**ADDENDUM #5**

**Will County Health Department**  
**BID PACKAGE #2 – Misc. Steel/Structural/Enclosure**  
**November 15, 2018**

**SECTION 00 91 07  
BP #2 - ADDENDUM NUMBER 5**

**PROJECT:**           **WILL COUNTY HEALTH DEPARTMENT - NEW HEALTH DEPARTMENT  
BUILDING  
501 ELLA AVENUE  
JOLIET, ILLINOIS 60433**

**EAST STAIR - ROOF LEVEL**  
SCALE: 1/4" = 1'-0"

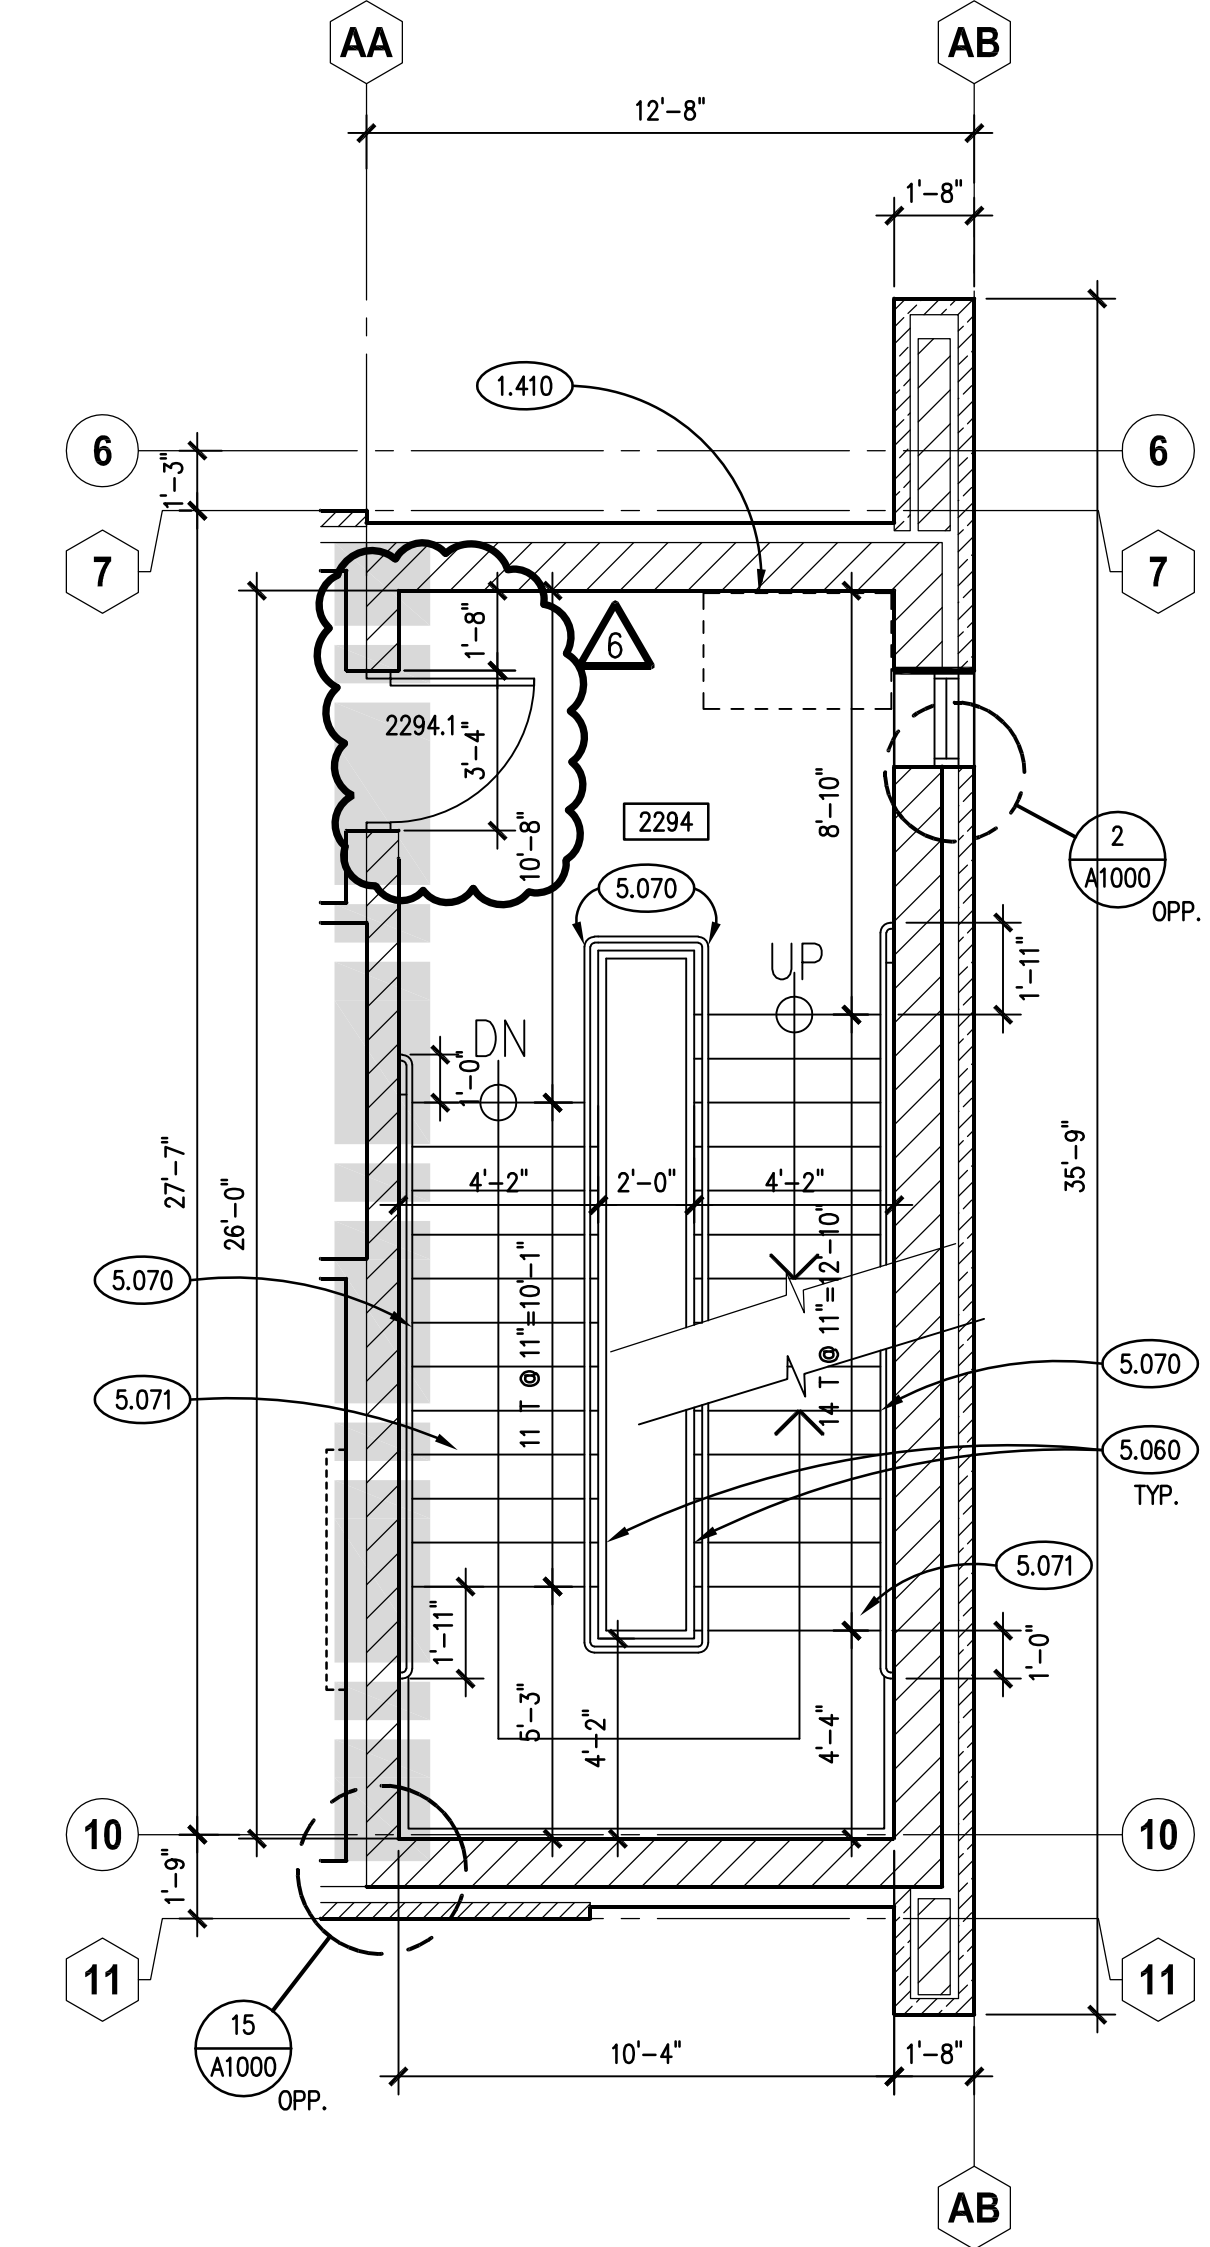
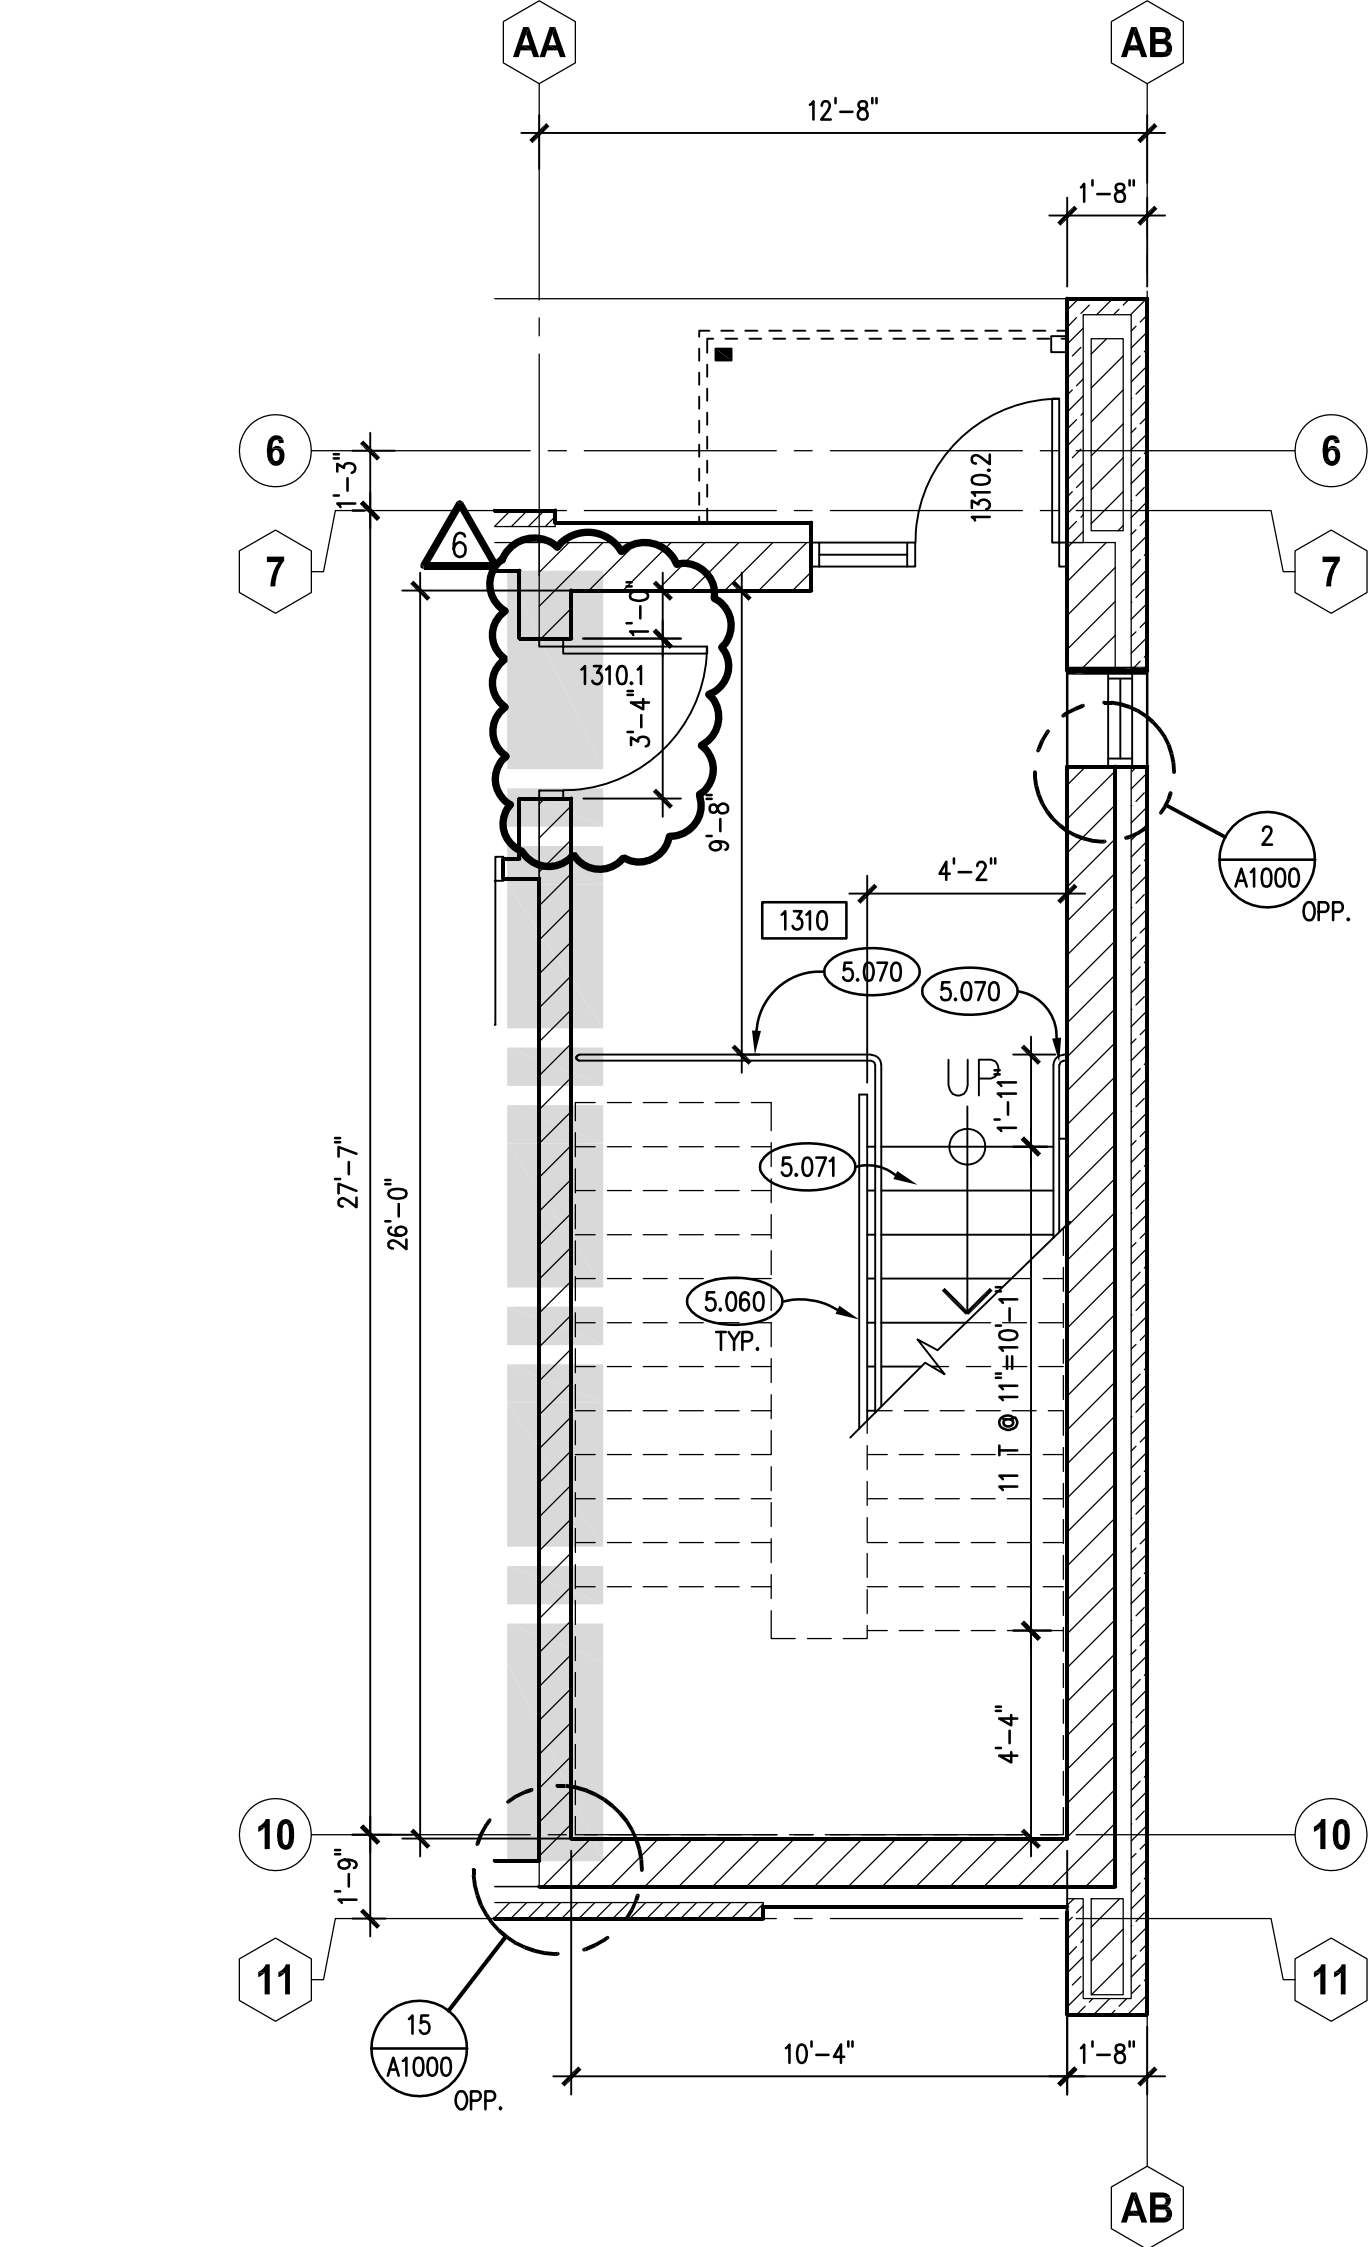
- A. Detail 8/A501: Added post location dimensions for the central handrail assembly at the ornamental staircase.

**BUILDING SECTION 2A**  
SCALE: 1/8" = 1'-0"

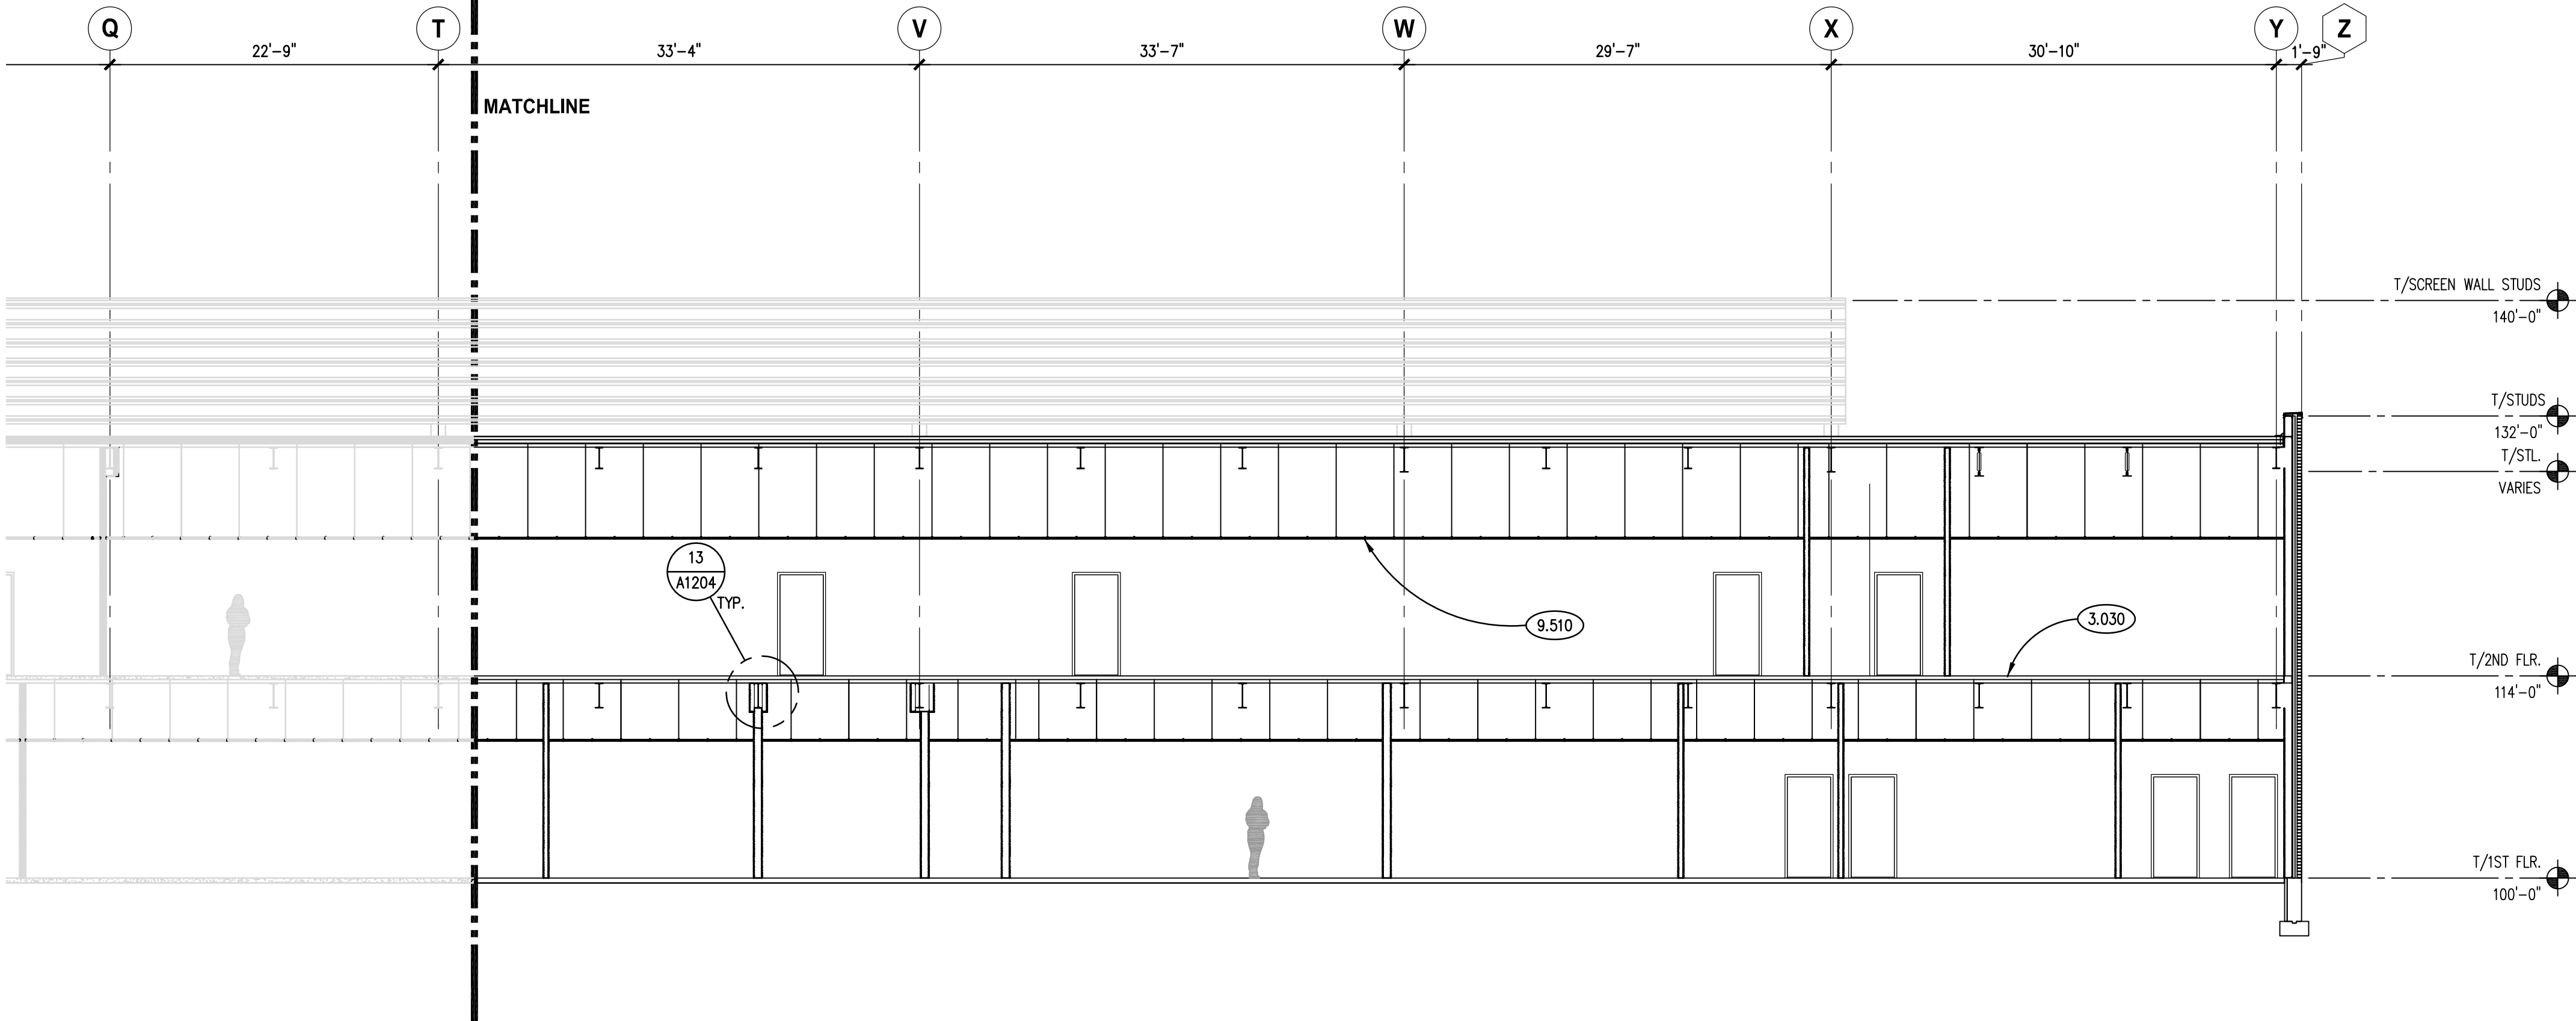
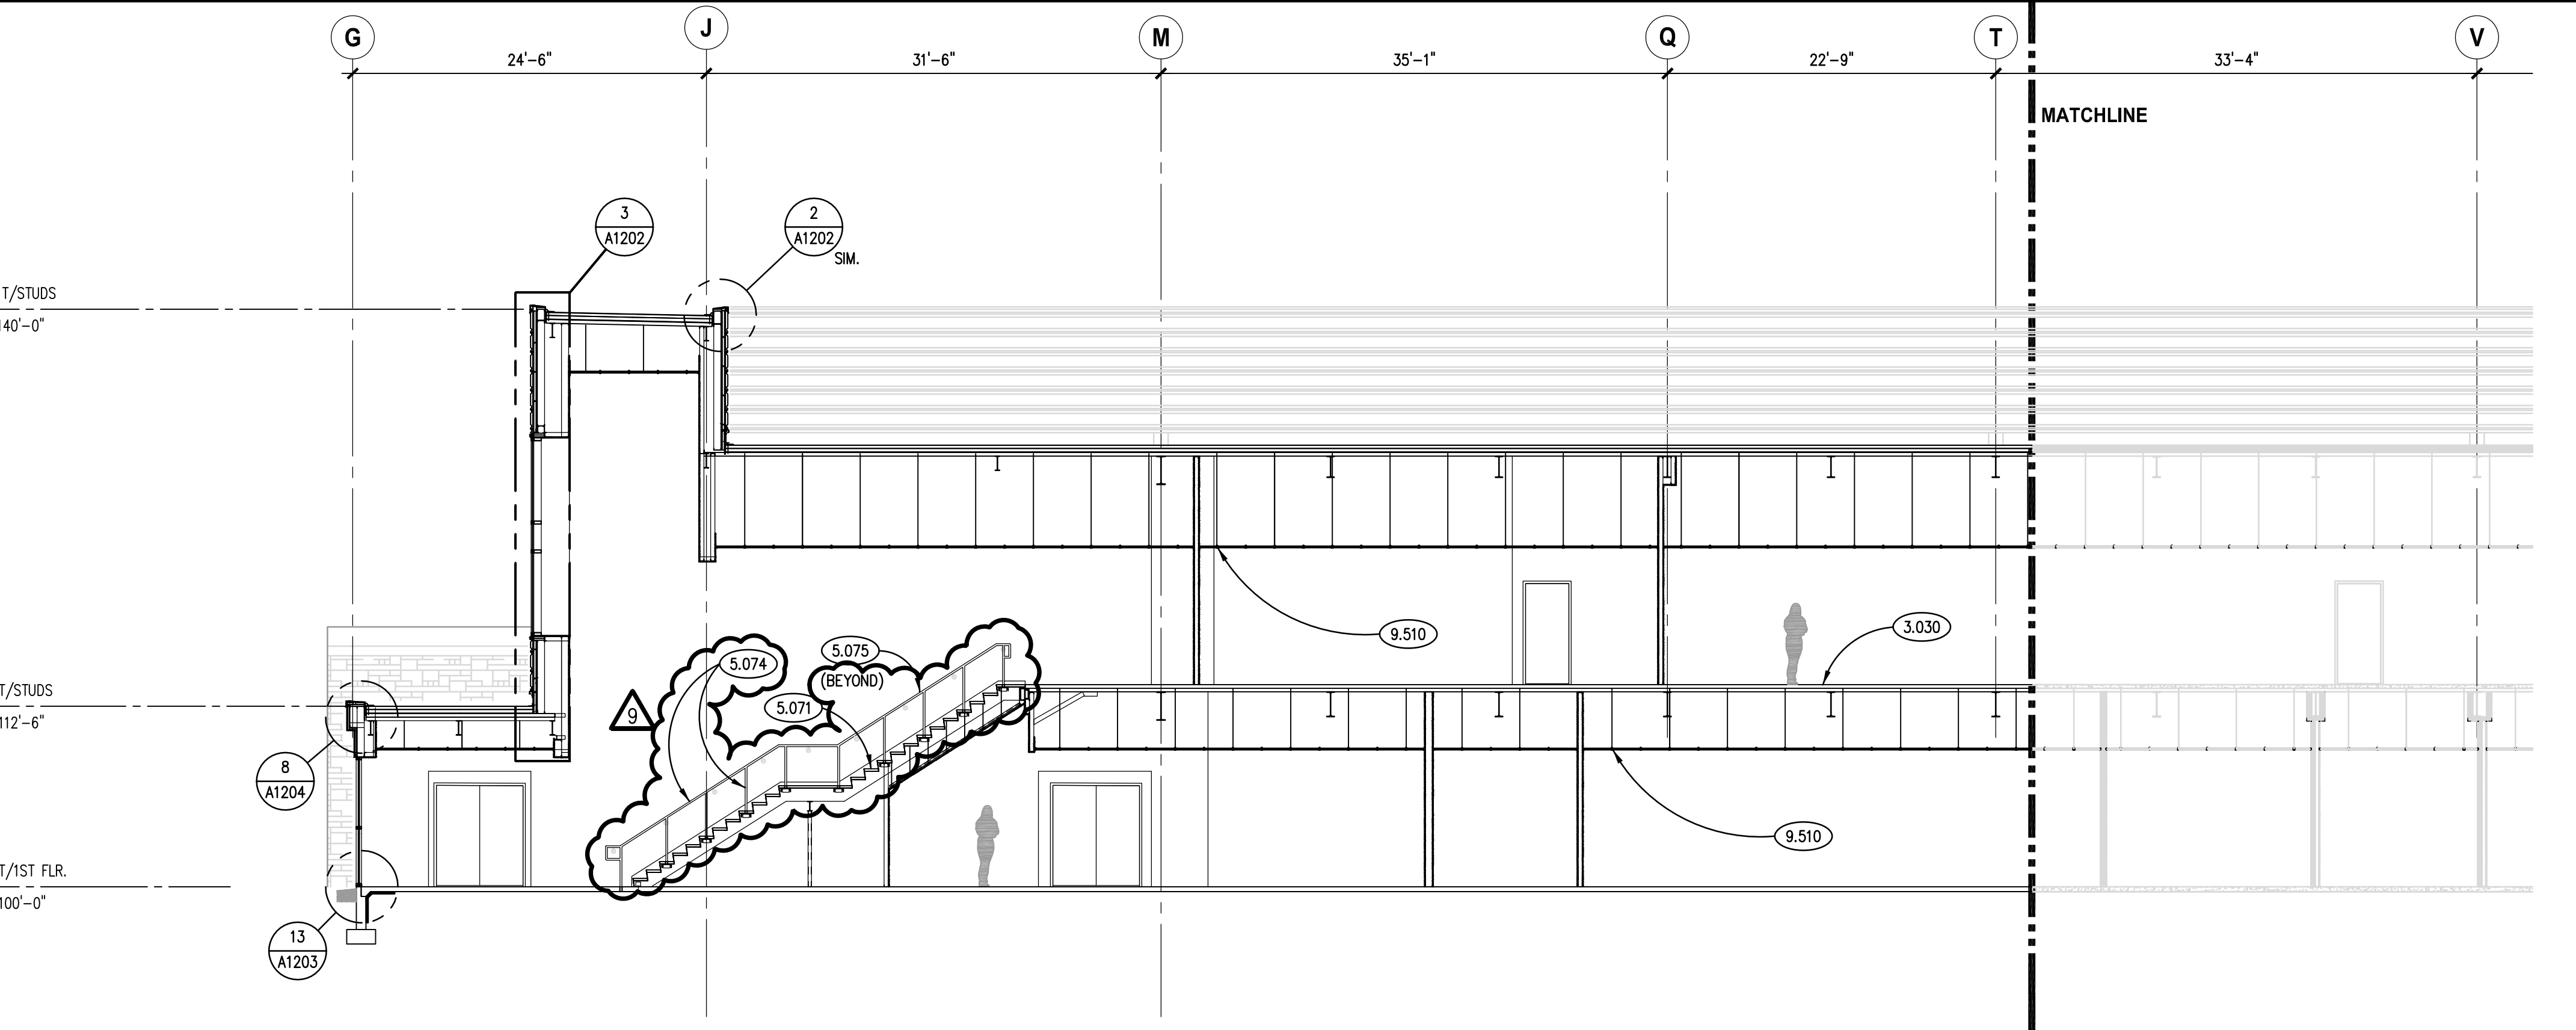
- A. Detail 2A/A501: Added ornamental staircase post locations and revised keynote 5.074.
